## NORFOLK BOREAS examination

### Oulton Parish Council: Submission at Deadline 1

Summary of Issues raised and discussed in all OPC's Written Representations that were submitted to the examination of **Norfolk Vanguard**:

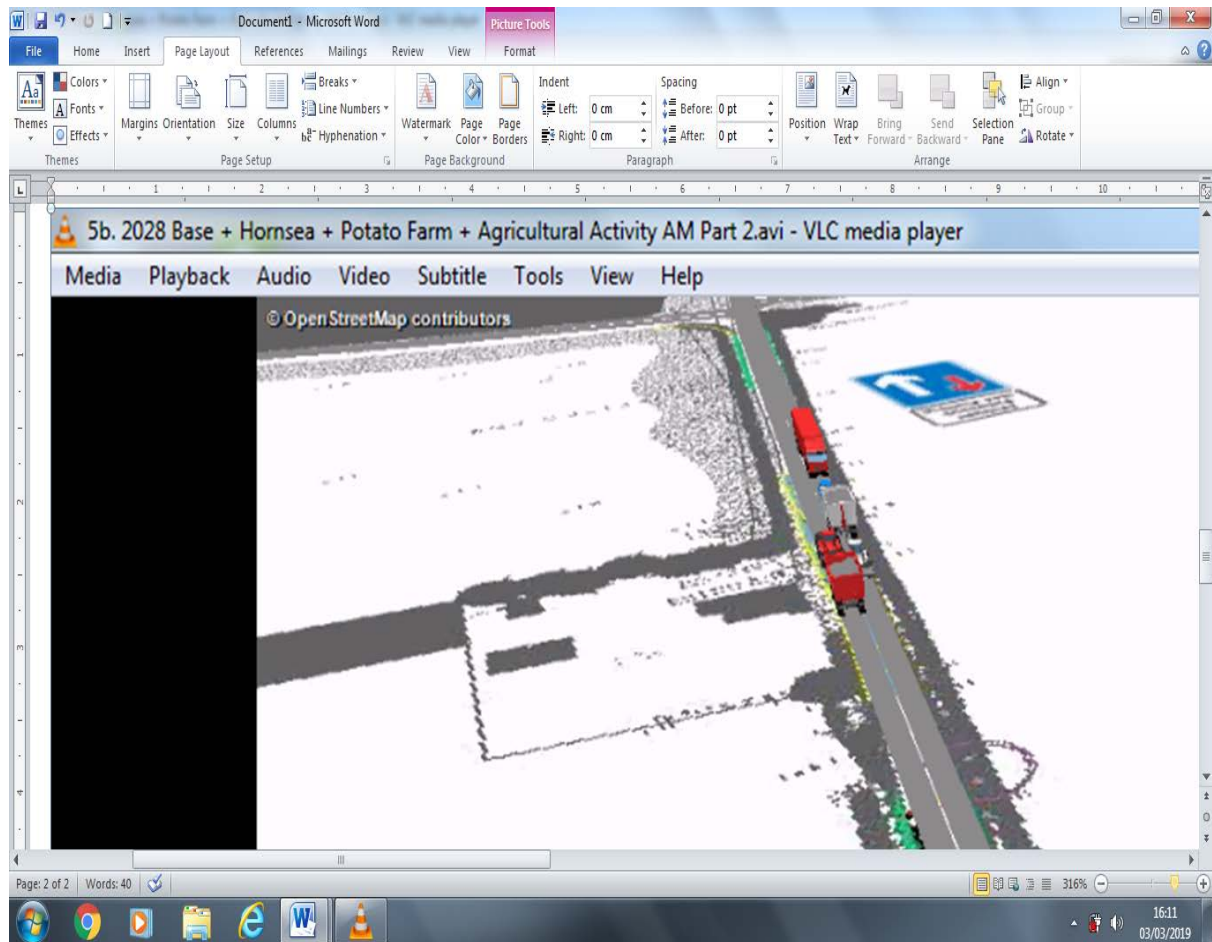
Finally, OPC note that Vattenfall Norfolk Vanguard are **NOT** proposing to use trench-less crossing (HDD) at the point where the cable route crosses the B1149. OPC believes that section of the road is not wide enough to create single lane-controlled traffic movements safely. It is a busy well used route to and from Norwich. Given that the traffic for both projects will be accessing this section of road how will this be managed without serious traffic delays affecting the wider road network?

There was a suggestion that if both projects were working beside each other at the same time where both projects cross or share access routes then one or other would halt their work to let the other progress by agreement. This doesn't take into consideration the effect on existing traffic which will include farm traffic, especially at harvest times throughout the year. Only recently, Street Farm, Oulton secured planning permission (BDC ref 20180491) for a 2200 tonne boxed potato store that will generate significant additional HGV traffic along The Street. Tourist traffic and residents would be inconvenienced by lengthy detours if there are road closures at this point.

OPC would urge the applicant to reconsider this decision not to use HDD at this location and understand that NCC Highways are also very concerned about this aspect.

**(Screen print 1)** Traffic did not adhere to the road intervention schemes.

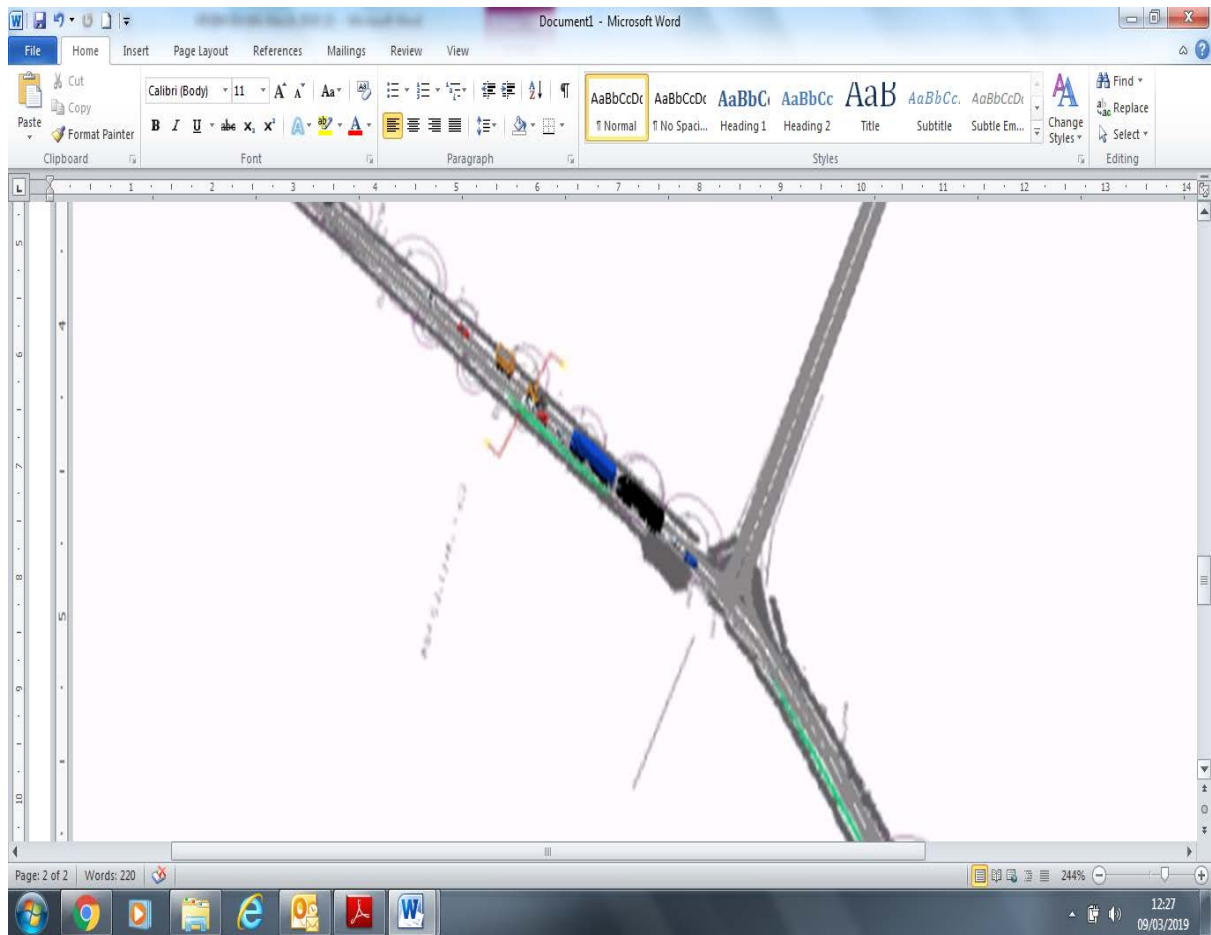
Location shown- The Old Railway Gate House. Orsted propose the road hump is graded with one-way priority signage. In this illustration traffic has ignored priority signs and tried to pass at the old railway hump. This part of the road is very narrow and is impossible for two vehicles to pass each other. Vattenfall have not proposed any changes to this location and OPC wonders how cable delivery vehicles will cope with this hazard.

(Screen print 2) Location shown – The Street at the entrance to Docking Farm. Passing places to be constructed by Orsted (shown in green) unable to accommodate all traffic if there were several vehicles following each other.

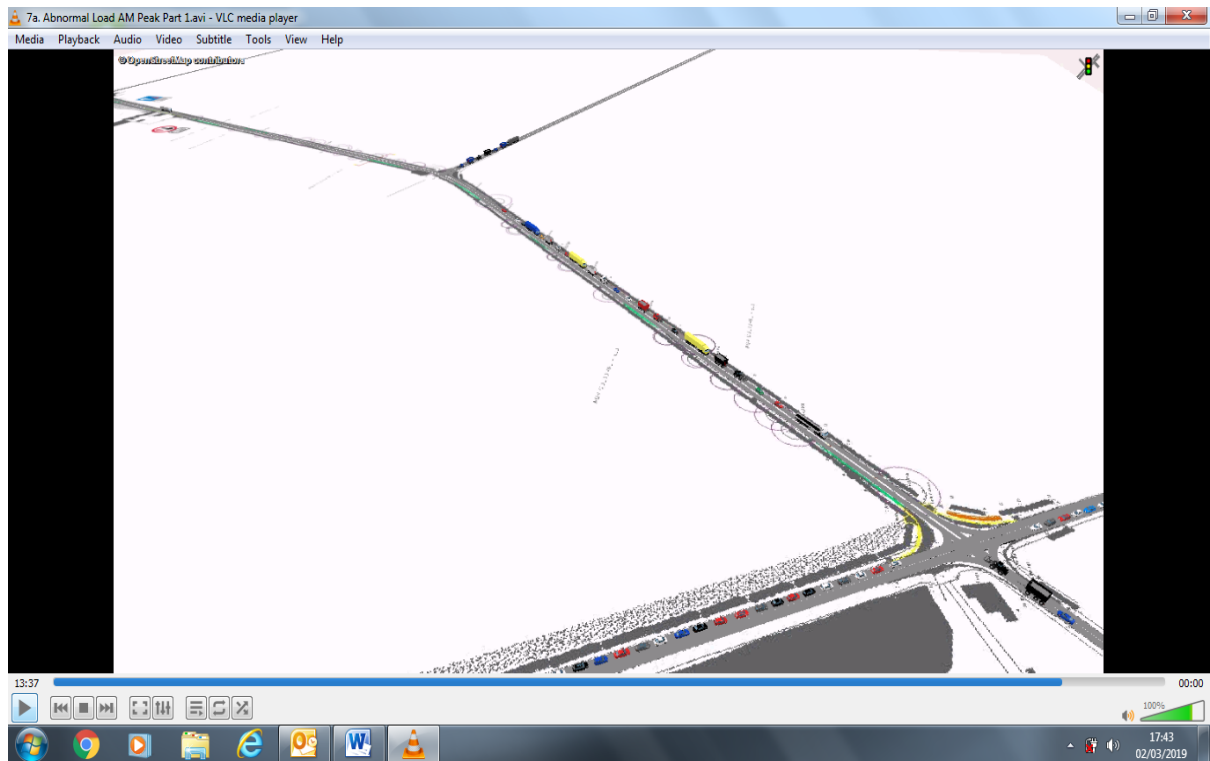
Vattenfall have not proposed any changes to the road. The amount of existing traffic together with the Orsted volumes would make the Vattenfall 'pilot vehicle' approach unrealistic.

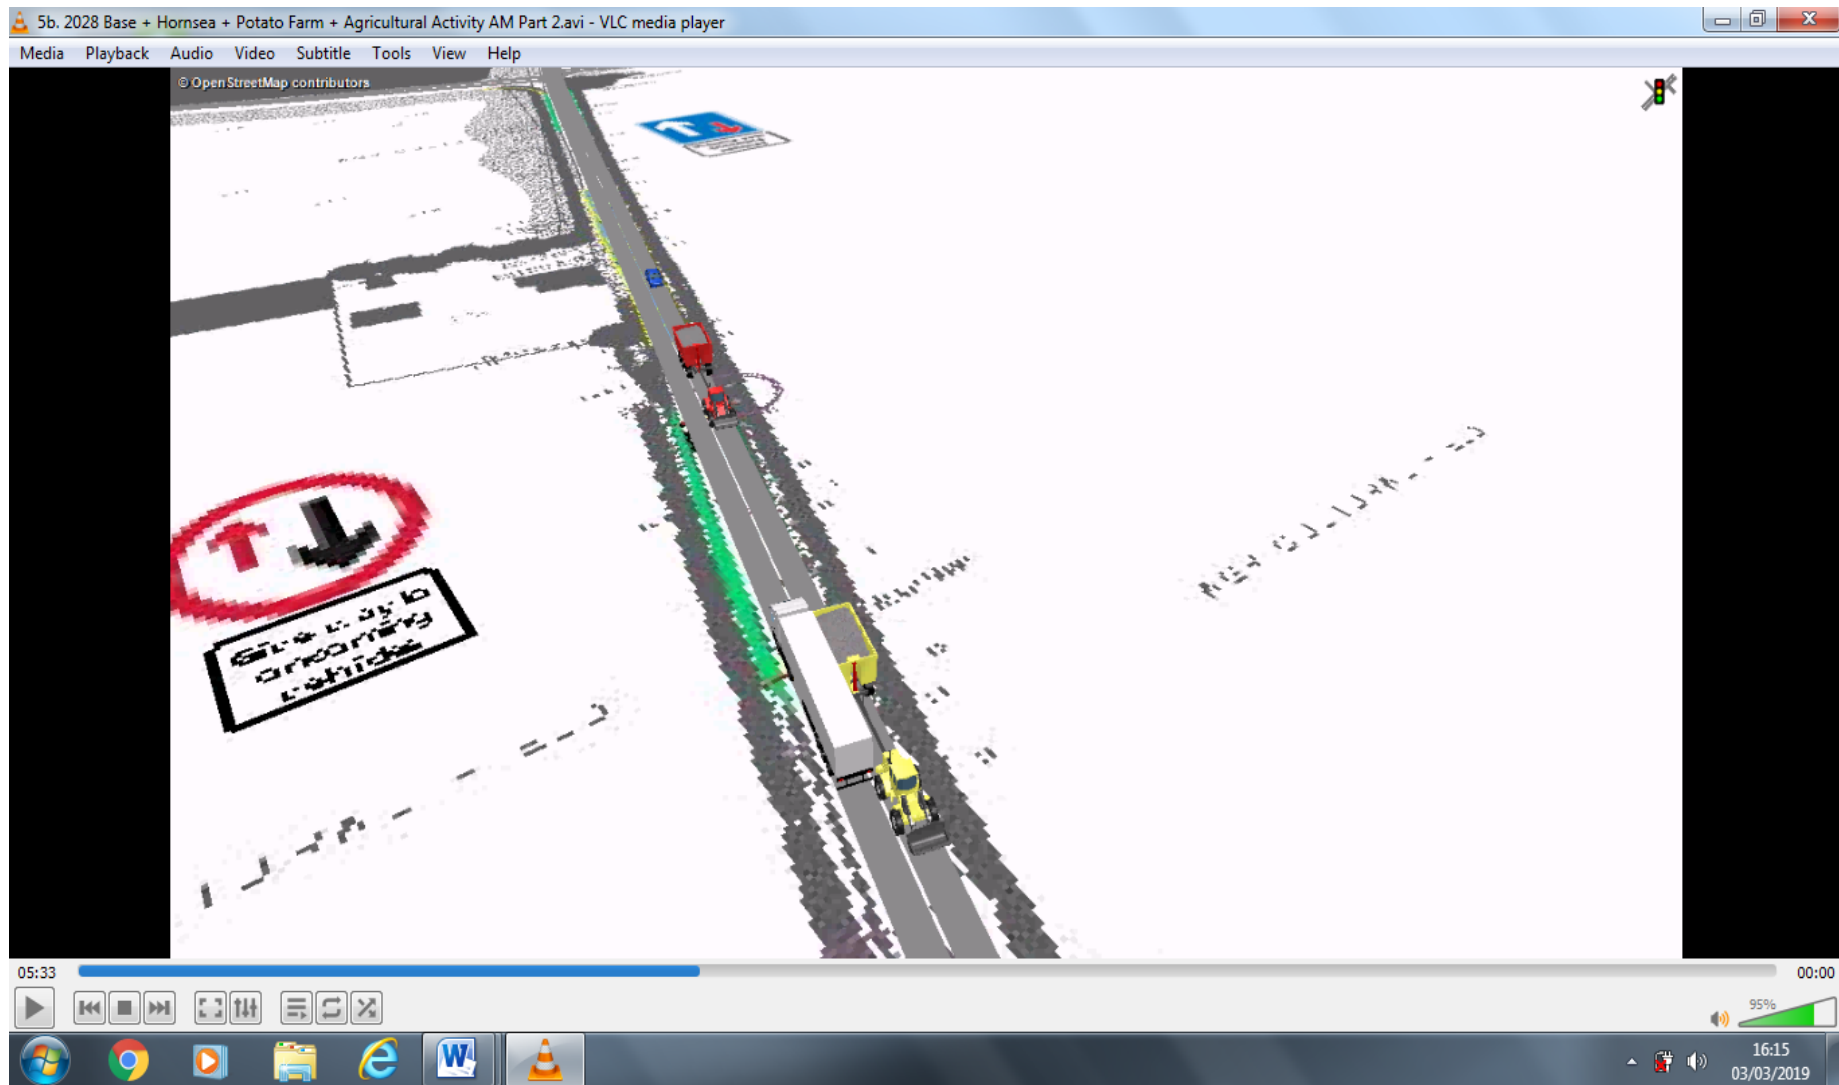
\*Priority signs at the hump next to the Railway Gatehouse not working: it would not be possible for two tractor/trailers or HGVs to pass at this point. The road width at this point is planned to be the same as currently.

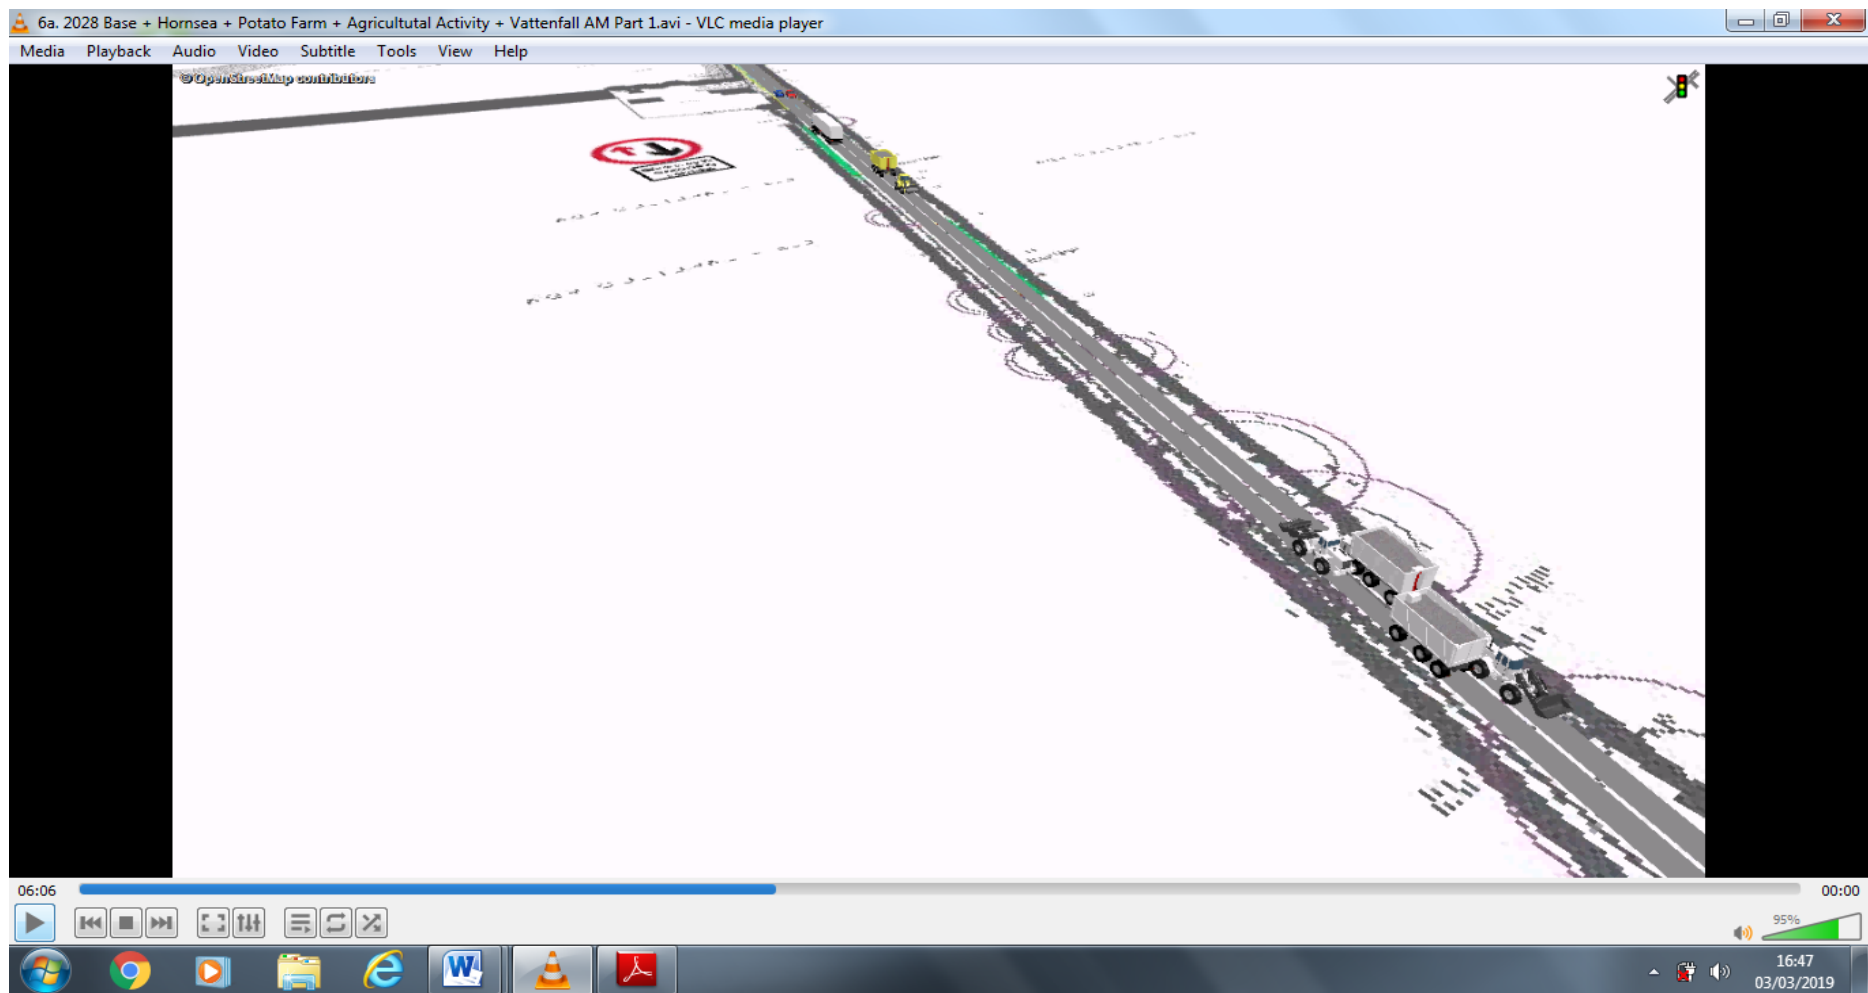
Data input error: one HGV and one tractor/trailer passing each other without use of passing place. This is impossible - the road is too narrow.

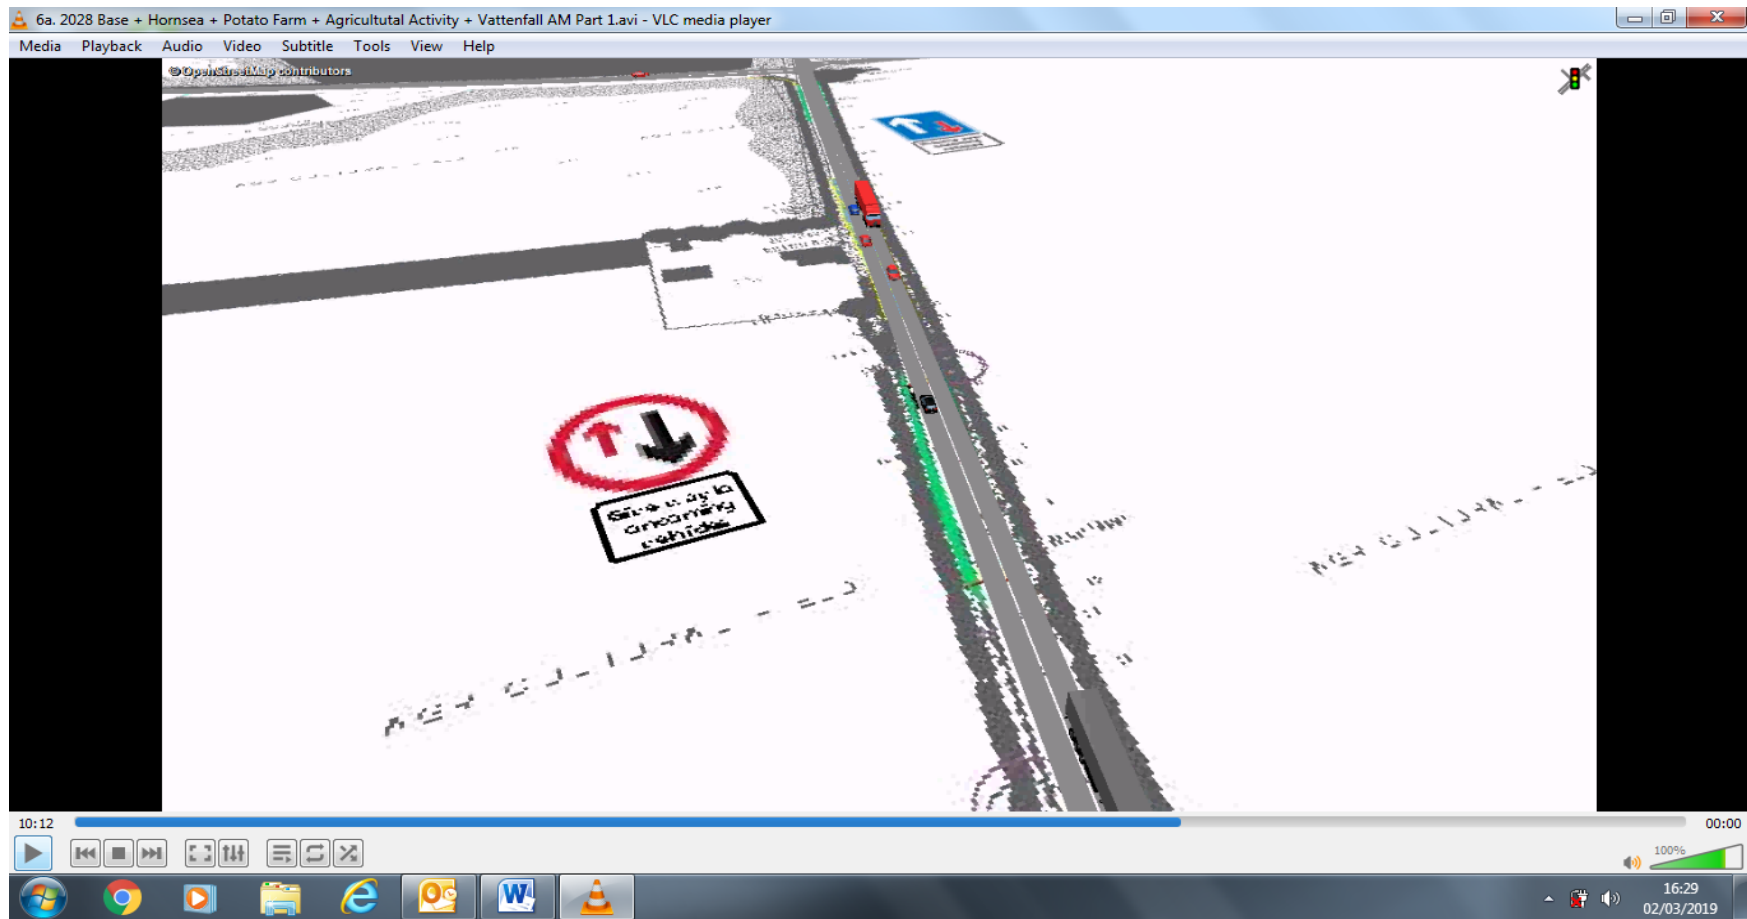
Two tractor trailers passing outside of passing places – this is impossible.  
[6a 2028 Base + Hornsea + potato Farm + agricultural activity + Vattenfall AM part 1.]

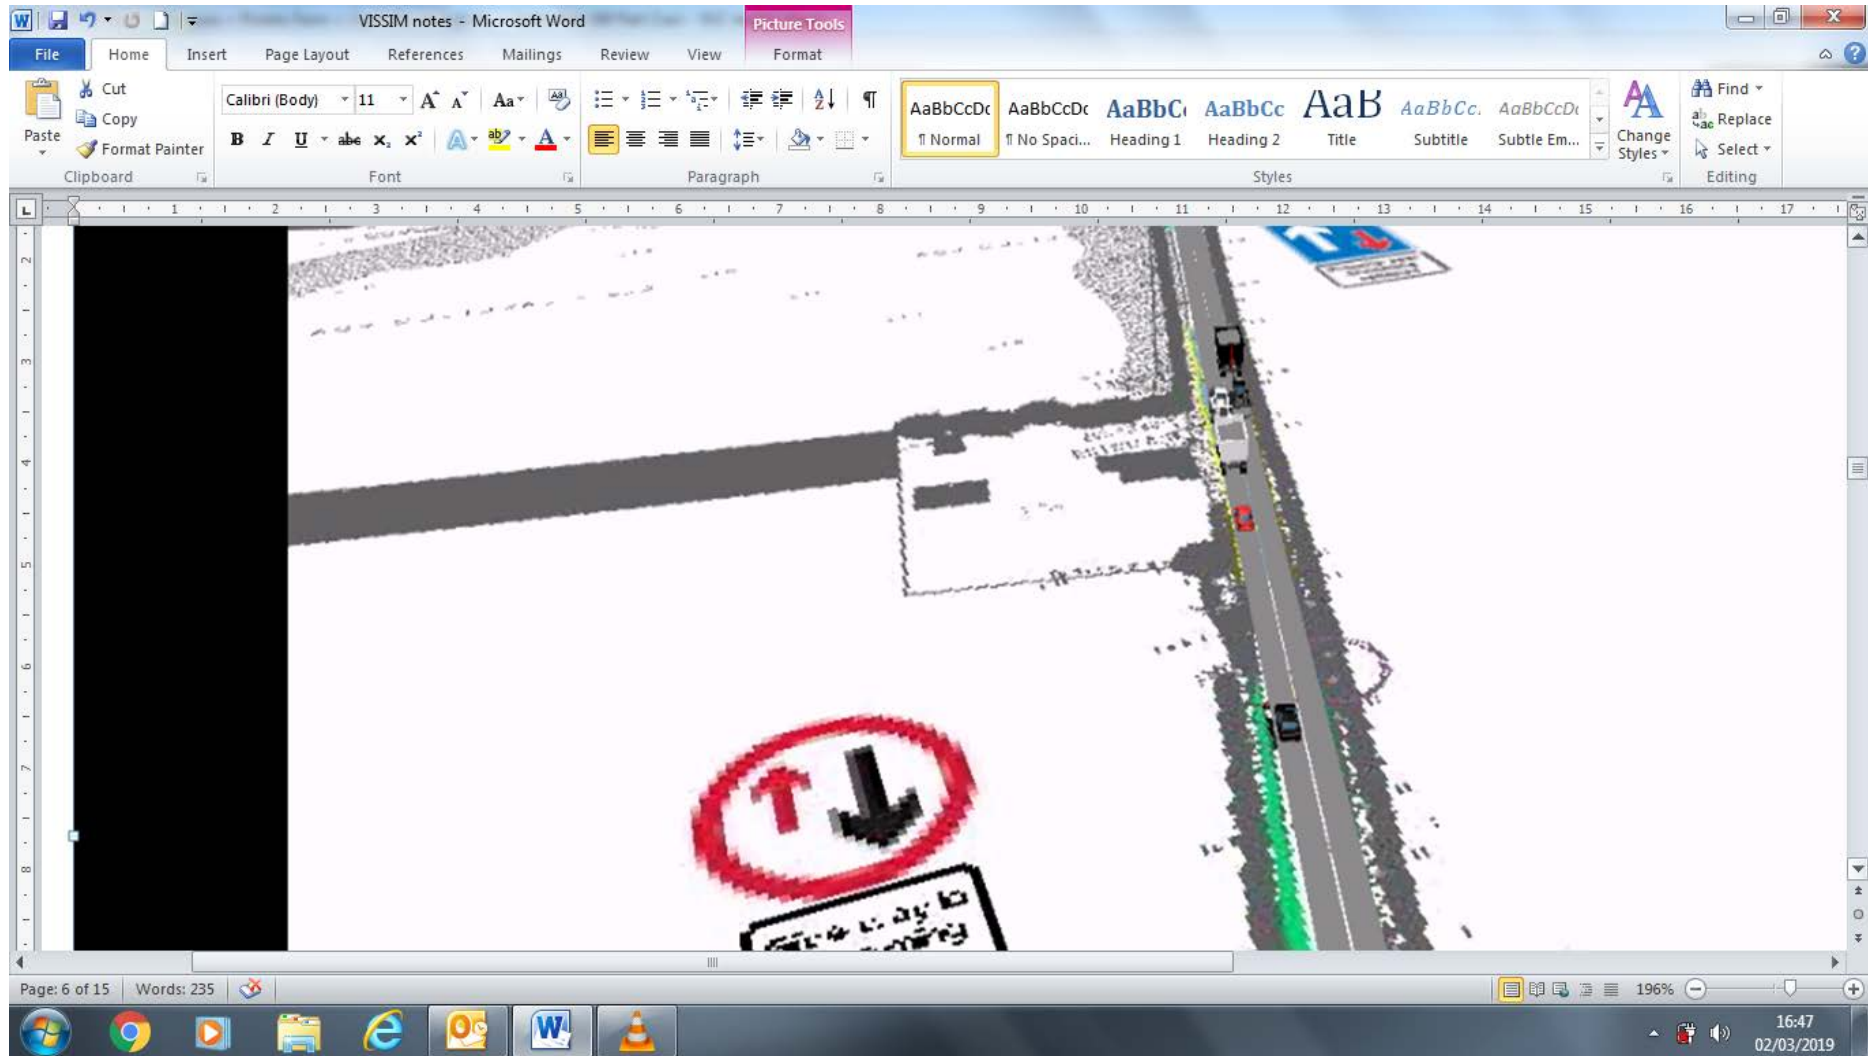
Priority signs not working at the hump: it is impossible for an HGV and a car to pass at that location.
